## Affected Products – RSE/RSOE series

Dear customers and distributors, we herewith inform you about Product Change Notice\* concerning the following products:

**RSE, RSOE series (all versions).**

Series	Component (before)	Component (after)
RSE and RSOE	PCB code: DCS-707	PCB code: DCS-707 rev.B

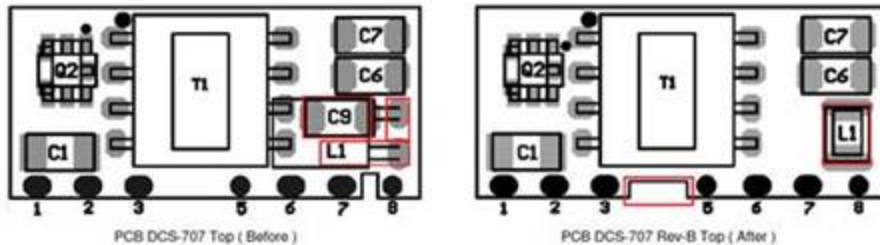
The electronics industry is moving to smaller-sized passive components and discontinuing the larger size formats. For example, 1206 resistor dimensions are migrating to 0805. It is therefore necessary to change the internal PCB layout of these products to accommodate the smaller standardized sizes.

We have also taken the opportunity to rearrange some the components on the PCB now we have more room and, in particular, to switch from through-hole to SMD-mount inductors. This is to improve the production yield and performance stability by increasing the automation grade of the converters.

The new PCB layout is identified by a notch between pins 3 and 5 so that it can be more easily identified by x-ray inspection after assembly.
